**LEGAL ADVERTISEMENT
HISTORIC PRESERVATION BOARD
CITY OF PORTLAND
Public comments are taken at all meetings.**

HISTORIC PRESERVATION BOARD AGENDA

**HISTORIC PRESERVATION BOARD
CITY OF PORTLAND, MAINE**

VIEW 1 - CONGRESS STREET

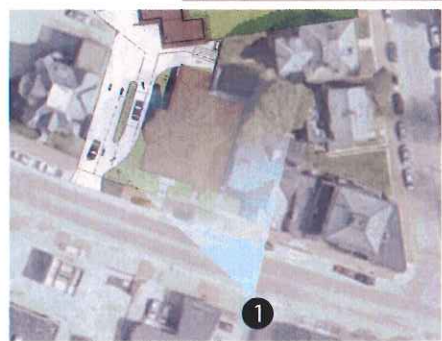
Board Comment Although positioned in an inside rear corner, some Board members cautioned that the penthouse would be quite visible from Congress Street. The applicant was asked to provide perspective views which showed the penthouse.

Applicant Response *The latest submission includes a computer-generated perspective view showing the penthouse as viewed from Congress. The penthouse remains as originally proposed.*

A2.02

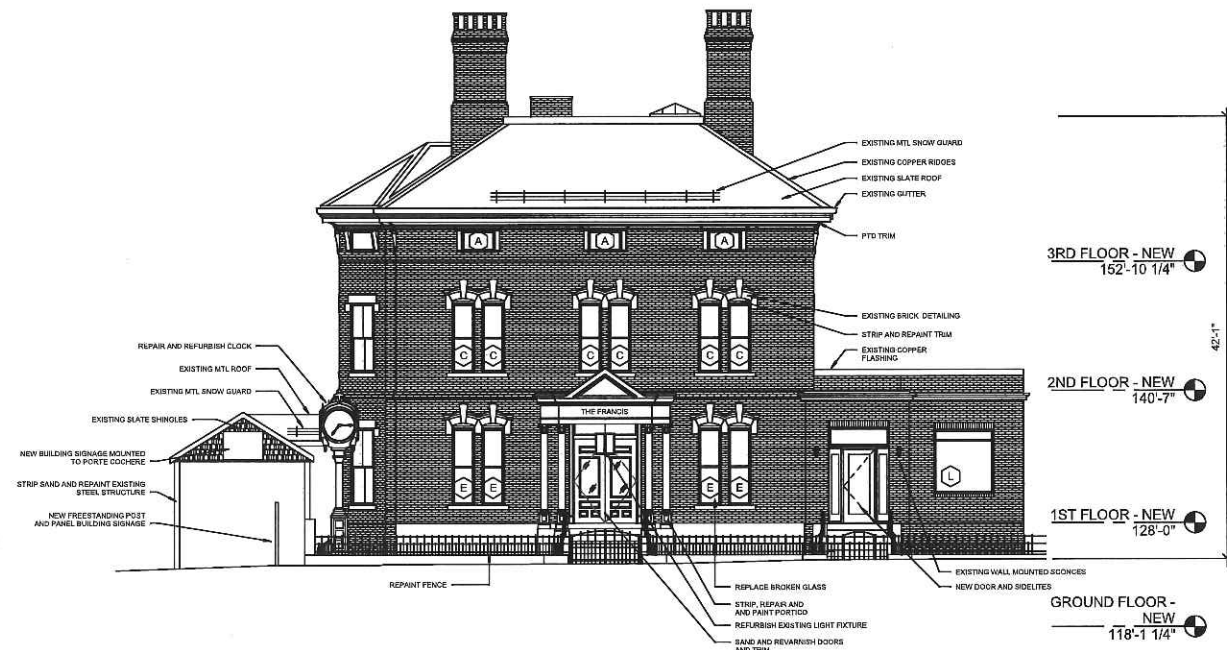
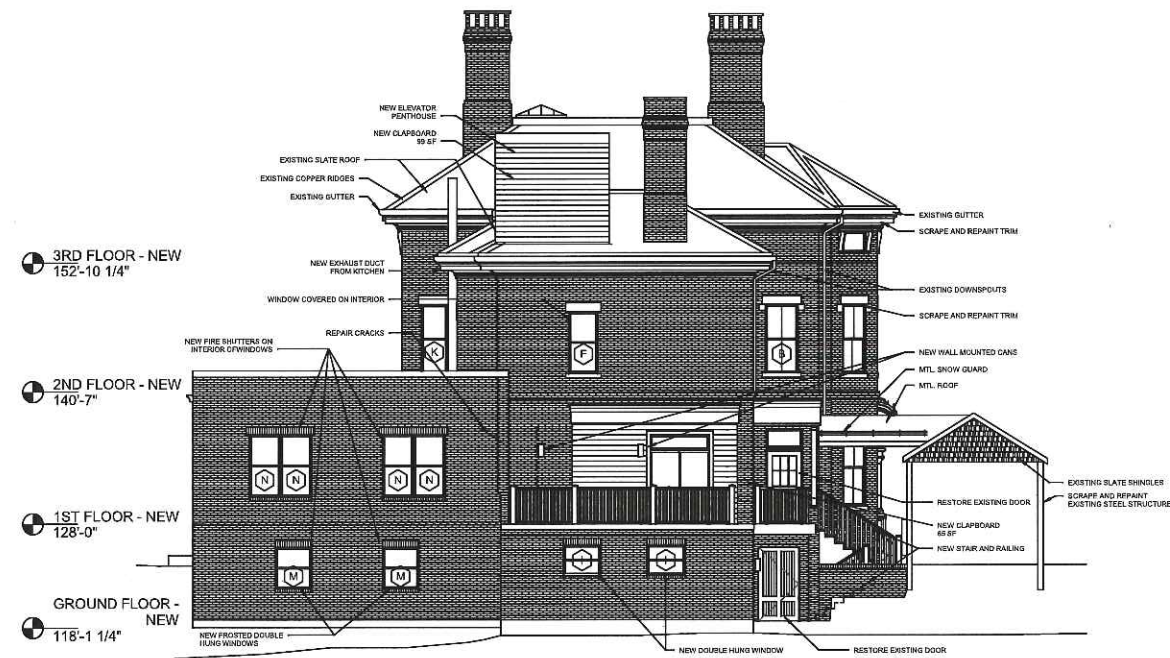
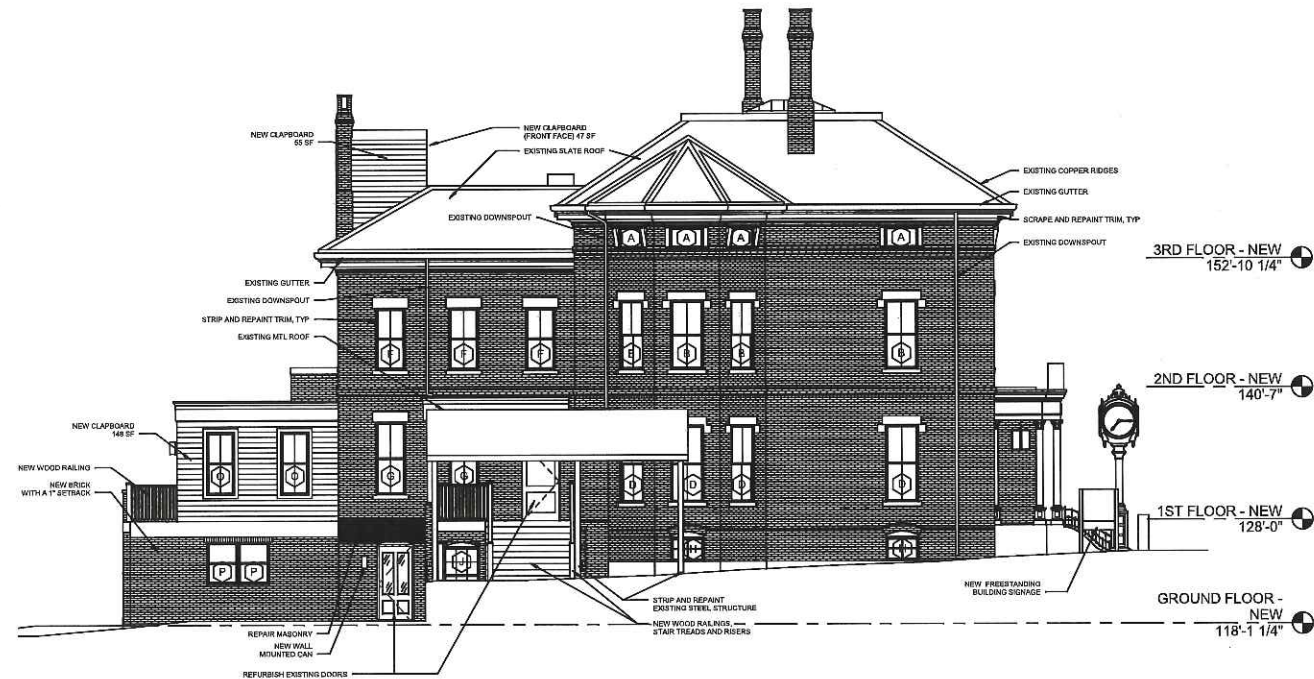
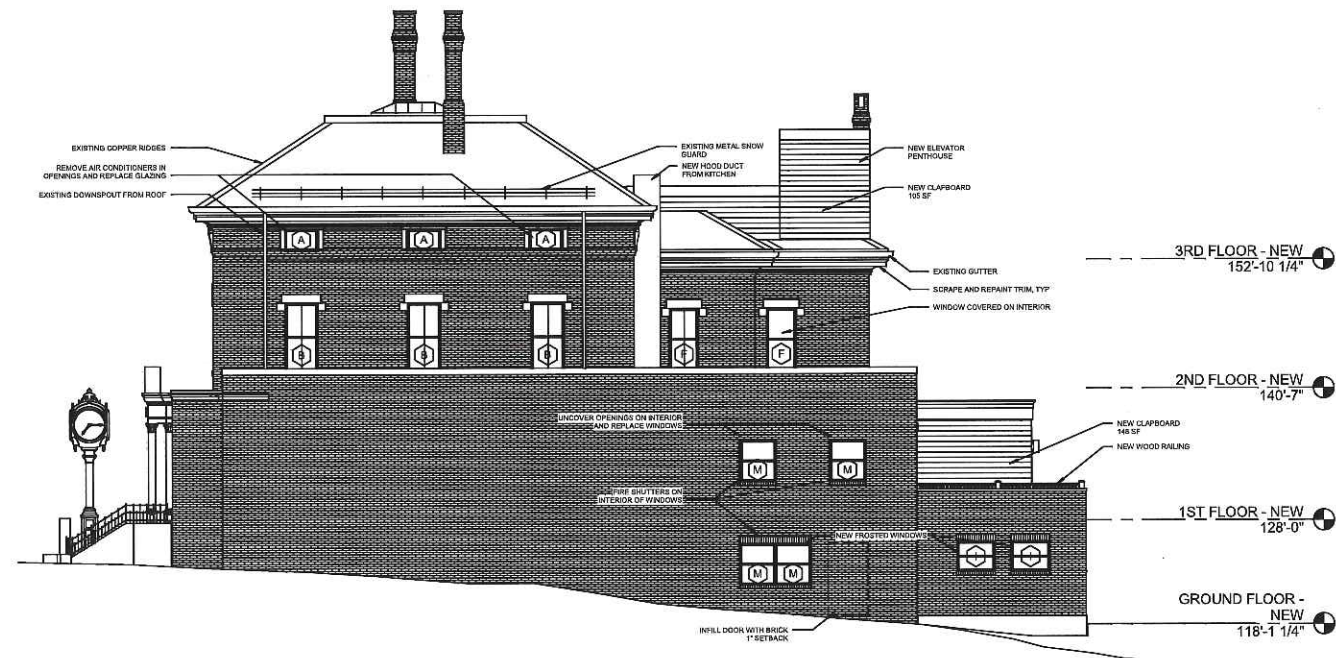
Board Comment Board members raised a number of questions about the architectural expression of the townhouses. Noting the prominence and architectural significance of the buildings along this section of Congress Street, the fact that there is no apparent precedent for buildings constructed within the interior of a block, and the clear visibility of the townhouses from Congress and Mellen Streets, Board members expressed the view that the new construction not visually compete with or distract from the existing historic buildings at the street. To that end, they argued that the architectural solution for the new townhouses should be fairly quiet, consistent and recessive.

Some Board members expressed the view that the unit closest to Congress Street was too close to the back of the historic structure and looked shoe-horned in. Questions were raised as to whether the entire row could be pushed back into the lot to provide more breathing room and distance between the existing structure and the new construction.

Regarding the treatment of the units themselves, Board members questioned the proposed alternation of brick and clapboard facades to define individual units, particularly where the overall façade was continuous. The architectural composition of the townhouse façades was questioned as well, especially in terms of how the first and second floor levels related to each other. The lack of alignment in the floor to floor fenestration was noted. Board members encouraged Mr. Lloyd to align the second floor balcony and sliding glass doors over the garage opening and reduce its size. Board members also questioned the alternating trim treatment over these 2nd floor openings and the alternating window patterns at the third floor levels. Board members also suggested that the entries be recessed to provide them with more prominence.

In staff's view, the townhouse elevations have also improved significantly since the first submission and are responsive to the concerns expressed by Board members at the May workshop. The composition of the front elevations is now much more orderly and the proportions of the openings more traditional in character. The recessed entries are also an improvement. Staff does question the introduction of granite trim around the entry openings, however. Granite trim seems unnecessary and incongruous in this circumstance. Staff also notes that the townhouses are shown, at least in the colored perspective views, in a light color scheme. Would a darker color scheme be more recessive? The question warrants some consideration.

Revised Proposal *Under the revised proposal, the front facade of each townhouse steps forward slightly as one moves into the interior of the property. All units now feature a consistent exterior material palette: brick base with granite trim around the main entrance, clapboards at the 2nd and 3rd floor levels and metal tile at the 4th floor level. The entries are recessed. Granite trim surrounds the entry openings.*

The fenestration has changed considerably. The divided-light sliding glass doors have been reduced in width and shifted to a position directly over the garage doors below. An individual double-hung window has been added above the ground floor building entry. Individual punched windows at the third floor level also align with the garage door and sliding glass doors below. A round window at this level is introduced in every other unit. Note that the number of glass divisions in the sliding glass doors have been reduced.

In the revised proposal, the brick base has been continued on the rear elevation. The sliding glass doors and balconies on the rear have been replaced with standard double hung windows. The stepped positioning of each unit is reflected on the rear elevation as well. No fencing is shown separating the rear yards of each unit.

SITE PLAN

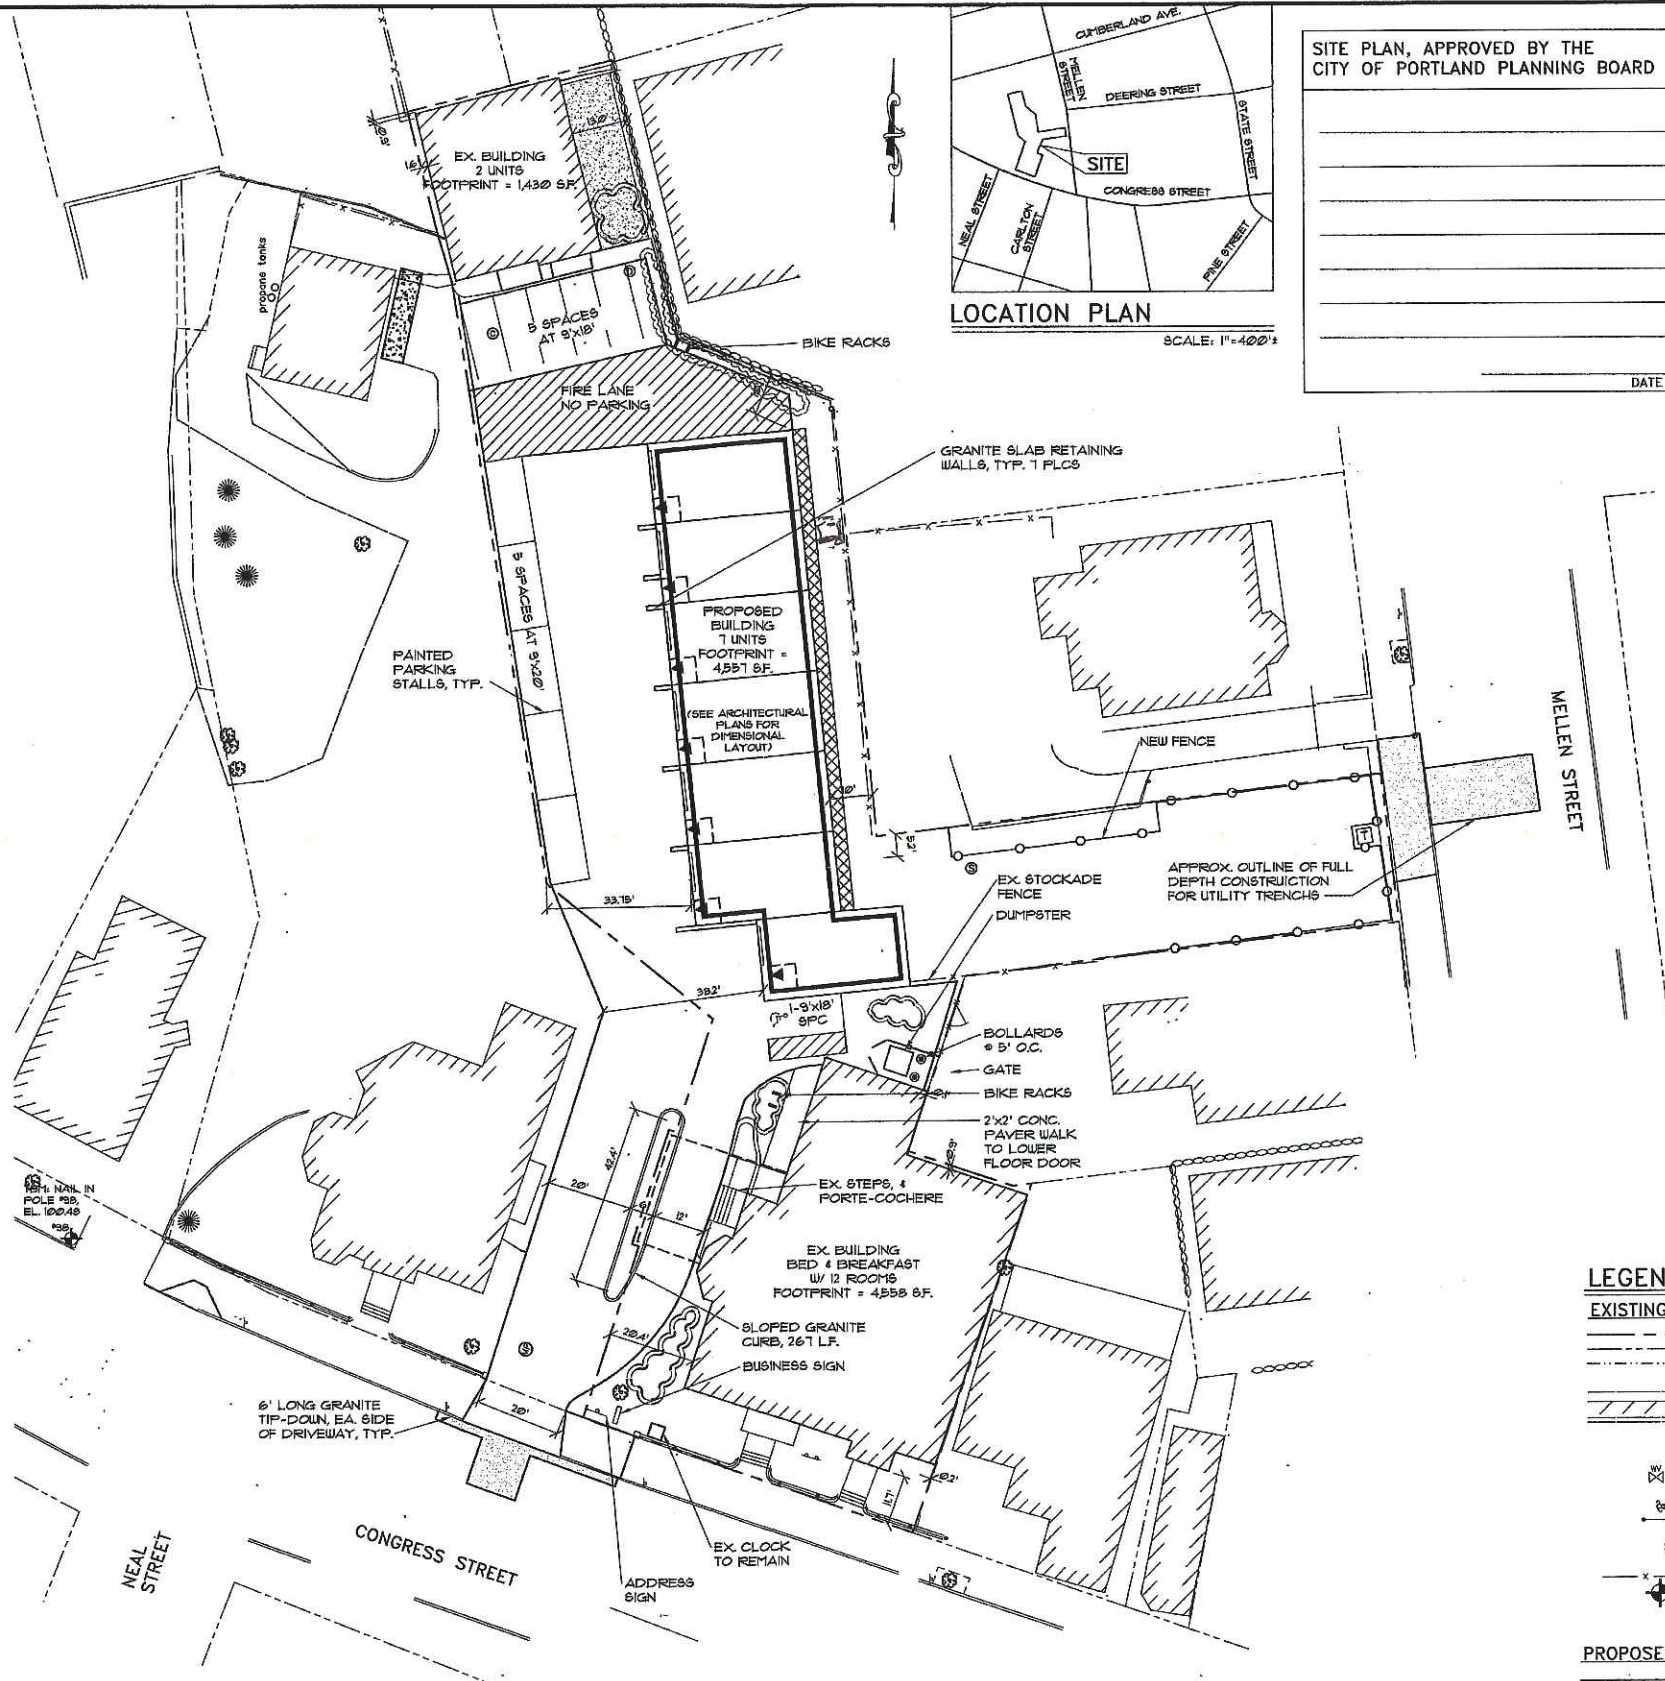
Board Comment A general and threshold concern expressed by several Board members was the lack of relationship and physical connection of the townhouses to the street. Board members observed that the siting of the townhouses appeared very suburban in that the units could only be entered off of a parking lot with no sidewalk or public amenities. They noted that pedestrian access from the public way is one of the defining characteristics of urban development and recommended that some way be found to provide a direct pedestrian link to and from the street.

The Board questioned plans for all the utility lines to run from Mellen Street through the wooded area that extends to the interior of the block. The proposal would require significant clearance within the wooded area (which was strongly opposed by neighbors) and siting of a large electrical transformer close to the Mellen Street sidewalk. During public comment, neighbors offered to provide an easement across their property to site some of the lines, which would avoid clearance of the wooded buffer. Questions were also raised as to why at least one or more of the utilities couldn't run from Congress.

Finally, questions were raised about the rear of the individual townhouses. Would individual fences separating the individual units be introduced?

Regarding the proposed changes to the site plan, that changes in utility locations is a significant improvement, allowing the vegetated buffer along Mellen to remain. However, staff does question the effectiveness of the proposed walkway solution in terms of meeting the Board's stated objectives. As proposed, the walkway runs directly in front of the townhouse units, stepping at each unit, then continues under the inn's porte cochere and directly in front of the west elevation of the inn. From there, it runs along the east edge of the driveway toward Congress Street. Staff questions the provision of a walkway where owners and guests of privately-owned townhouses must pass through an area that clearly reads as part of another use and property. Is it not possible to design a shared road/walkway solution that could further separate the walkway from the inn? Perhaps the walkway could cross the pavement and run through the landscaped median west of the porte cochere toward the street. This treatment would be akin to a shared "woonerf" treatment where the roadway and walkway are shared and at the same grade. Used extensively in Europe, woonerfs are used increasingly in this country as well.

Revised Site Plan *The latest site plan includes a 4' wide continuous brick walkway in front of the townhouses. Note that the walkway is stepped, with the steps corresponding to the frontage of each unit. From the townhouse closest to the Bolster House, the walkway continues toward Congress Street, passing under the porte cochere that serves the inn and immediately abutting the west side of the historic structure.*

At the western edge of the paved parking area, the site plan now shows bollards spaced 10' apart to delineate the applicant's property from the abutters and provide some definition for the parking area.

In the revised plan, the electrical transformer has been removed from its previous position adjacent to the Mellen Street sidewalk. Also, all utility lines have been removed from this area, allowing the wooded buffer to remain unchanged. Easements offered by abutters at 24 and 30 Mellen Street have allowed the lines to run across portions of their properties which are already cleared.
